Project Title: Land to the North of Arborfield Road

Project No/ Document Reference: HD008/TN004 RevB

PLANNING APPLICATION WBC 242484 / RESPONSE TO ENVIRONMENT AGENCY COMMENTS

Figure 1 – Modelled watercourses (from Enzygo report SHF.1154.040.HY.R.004.A, Nov 2025)

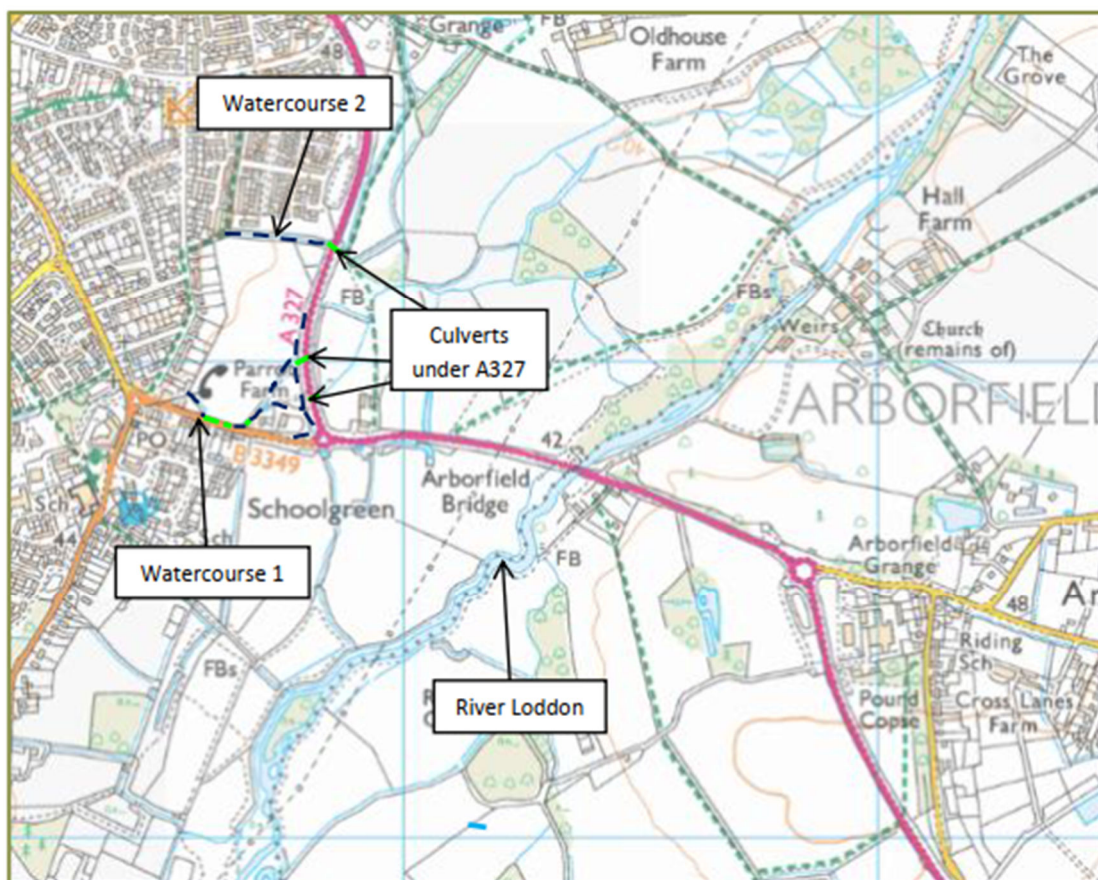
- 2.2. The FRA refers to flood modelling of the River Loddon completed by WBC for their 2021 Strategic Flood Risk Assessment (SFRA), and the EA response to the application noted that the submitted FRA failed to demonstrate that the flood modelling used in the FRA is appropriate.

- 2.5. The model was undertaken for WBC and a complete model history, confirming the date and source of all geometry and hydrology data is not available. As such, it is not possible for a comprehensive check on the suitability of all aspects of the model for the purposes of a site specific FRA.

- 2.6. Furthermore, the model is an inundation model for the Loddon and considers the flooding resulting from overtopping of the Loddon channel and does not discretely model the tributaries of the Loddon to the west of the river and in close proximity to the site.

- 3.1. To address the EA comments a new flood model has been produced using 1D2D ESTRY-TUFLOW software for the western tributaries adjacent to/ within the site and a 2km reach of the River Loddon. **Figure 1** shows the watercourses included in the modelling.

- 3.2. This modelling uses channel survey data obtained in July 2025 and has been run in the current versions of the software.
- 3.3. Hydrological analysis has been undertaken for the new modelling and uses current catchment descriptor information as well as the current versions of FEH Statistical and ReFH2 software to complete the analysis.
- 3.4. The modelling study covers a suitable extent to inform the site-specific FRA and uses current methodologies and data.
- 3.5. The hydrological and hydraulic modelling is detailed in full in the attached reports:
